LIMERICK GENERATING STATION UNITS 1 & 2
ENVIRONMENTAL REPORT - OPERATING LICENSE STAGE
REVISION 6 PAGE CHANGES

QUESTION E310.3 (Section 2.1)

LIMERICK GENERATING STATION
 UNITS 1 AND 2
 ENVIRONMENTAL REPORT

TYPICAL LIGHT WIND TRACES

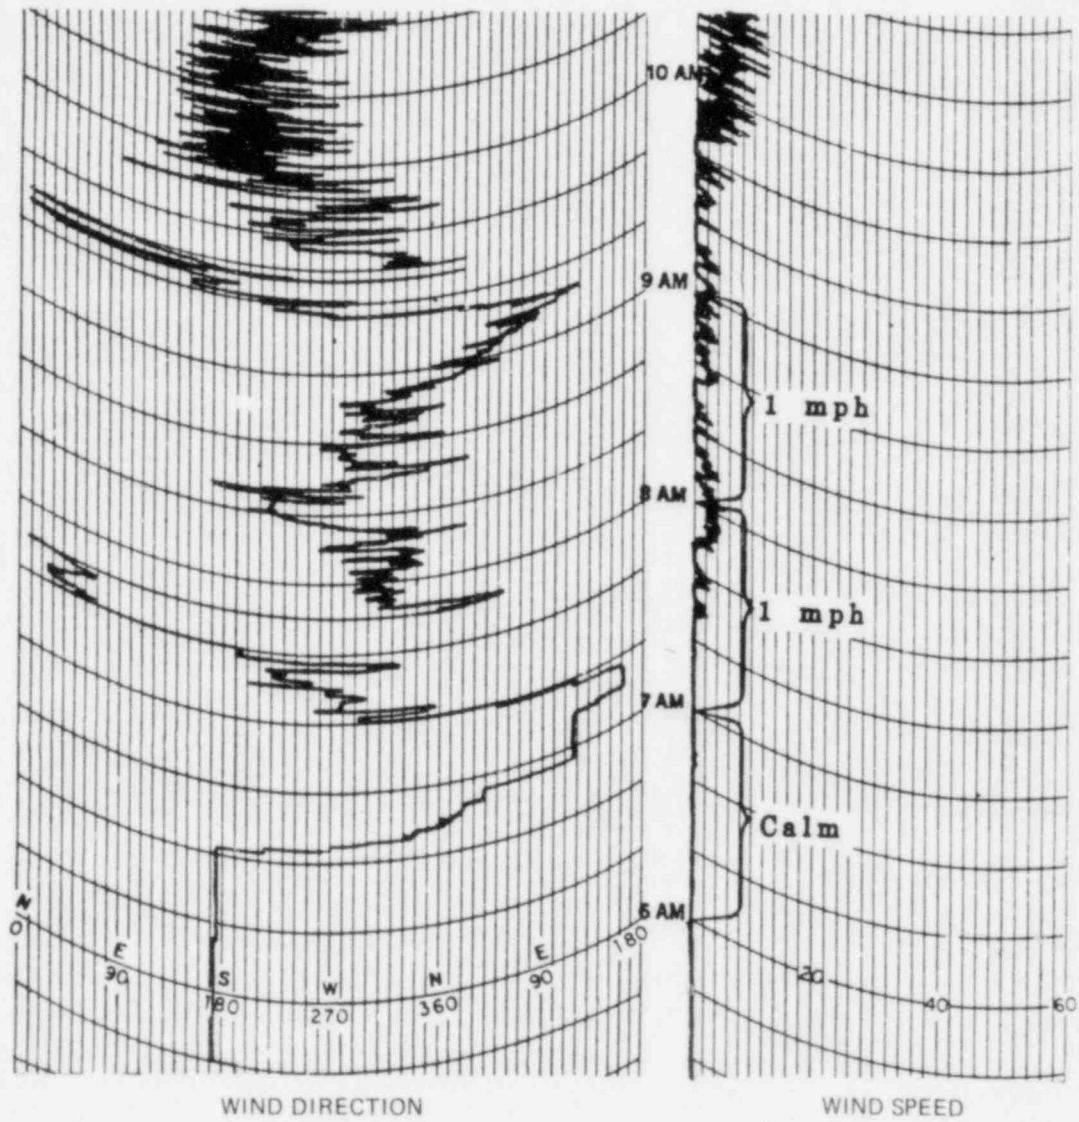
Tables 2.3.2-26 through 2.3.2-31 present wind direction frequency distributions and Tables 2.3.2-2 through 2.3.2-25 present joint frequency distributions of wind direction and wind speed by atmospheric stability class. In both of these sets of distributions, calms are distributed by wind direction.

- (1) Provide the definition of calm wind conditions, based on data reduction procedures, used to produce the frequency of calms in the tables.
- (2) Provide a description of how the calm conditions were distributed according to the joint frequency of wind direction, wind speed and atmospheric stability class (vertical temperature difference method) in the tables and provide the actual frequencies of calm distributed by wind direction and atmospheric stability.

- (3) Provide the basis for any departure from the definitions of calm in Regulatory Guide 1.111. Regulatory Guide 1.111 states that calms should be defined as hourly average wind speeds below the starting speed of the vane and anemometer, whichever is higher, and that calms, in joint frequency distributions should be assigned, as a separate wind speed class, to wind directions in proportion to the directional distribution, within an atmospheric stability class, of the lowest noncalm wind speed class.

In addition, MES chart readers are trained to distinguish a calm wind trace from a 1 mph trace based on an analysis of both the speed and direction traces. Figure E451.7-1 shows typical light wind speed traces,

and an example of the differentiation between calm and 1 mph wind speeds. The hours ending at 6 and 7 a.m. are calm wind traces, evidenced not only by a 0 mph wind speed, but also by a "boxy" directional trace. However, during the hour ending at 8 a.m. and continuing into the following hour, both the speed and direction traces have become active, with speeds fluctuating between 0 and 2 mph. Both of these hours would be read as 1 mph.

FIGURE E 451,11-1

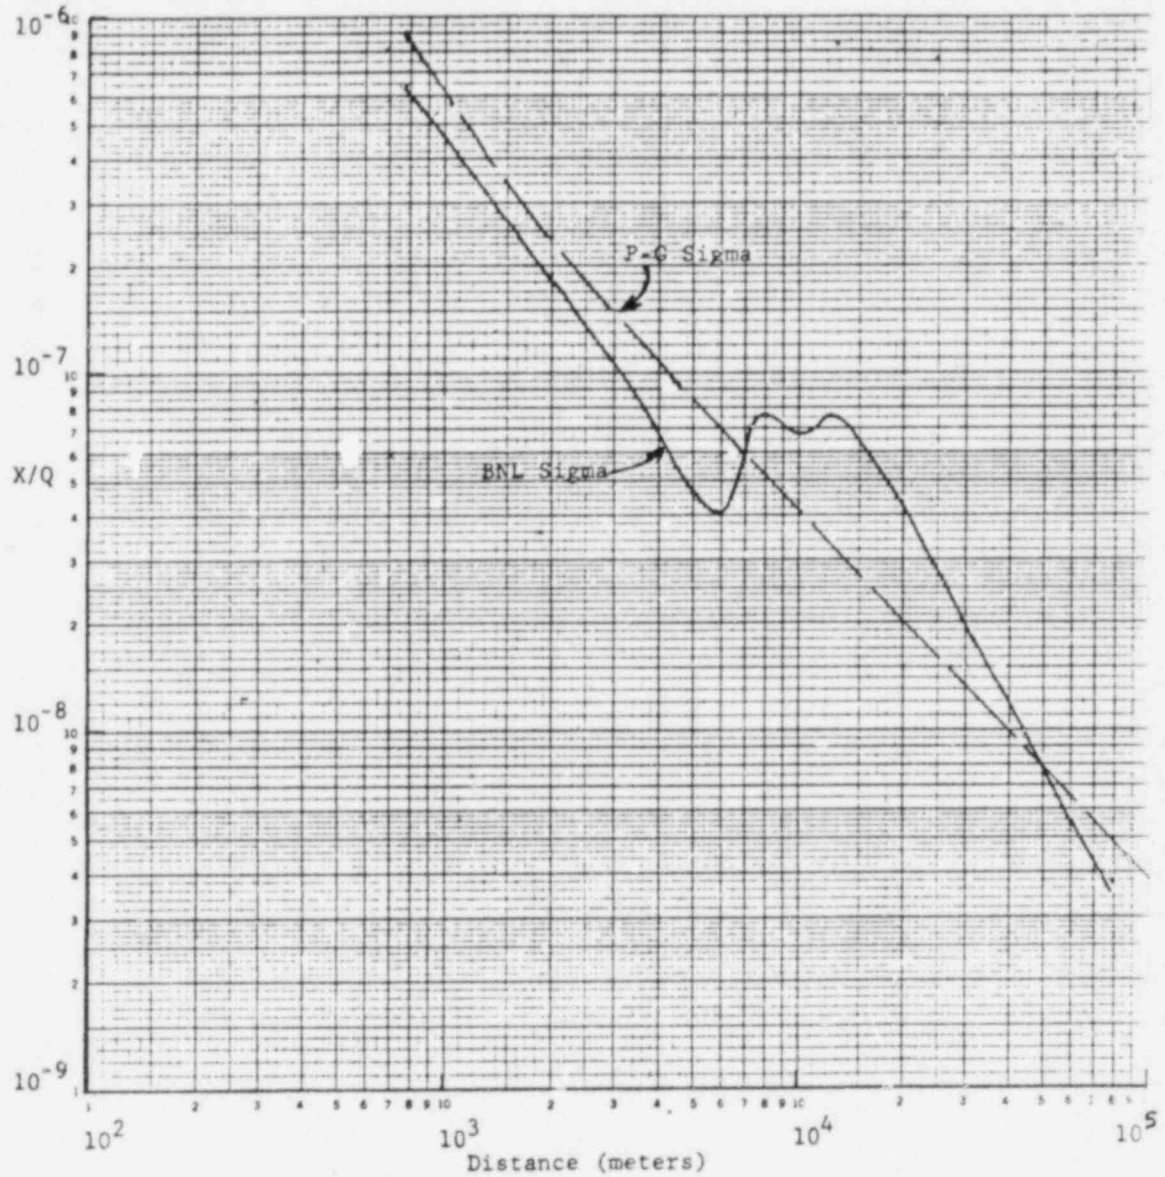
Since the long term diffusion estimates are based on wind measured at the 175-foot level and atmospheric stability is based on the Brookhaven Turbulence Class System and the Smith-Singer vertical dispersion coefficients,

- (1) provide the basis for utilization of these parameters, because they differ from those primarily recommended in Regulatory Guide 1.111, and
- (2) provide a comparison of these diffusion estimates with diffusion estimates based on wind measured at the 30-foot level and vertical temperature difference as the stability indicator with vertical dispersion curves as indicated in Regulatory Guide 1.111.

Figure E451.11-1 shows a comparison of the annual X/Q values from EROL Table 5.2-4, which were computed using Brookhaven dispersion coefficients. These values represented by the dashed line are from a similar calculation with ΔT stability and the P-G dispersion coefficients of Regulatory Guide 1.111. The comparison shows that the Brookhaven coefficients were more sensitive to terrain elevation because the lower portion of the mixed mode release is set at 10 meters in the BNL model, as compared to a ground level release in the Regulatory Guide 1.111 model. Otherwise, the values are quite similar.
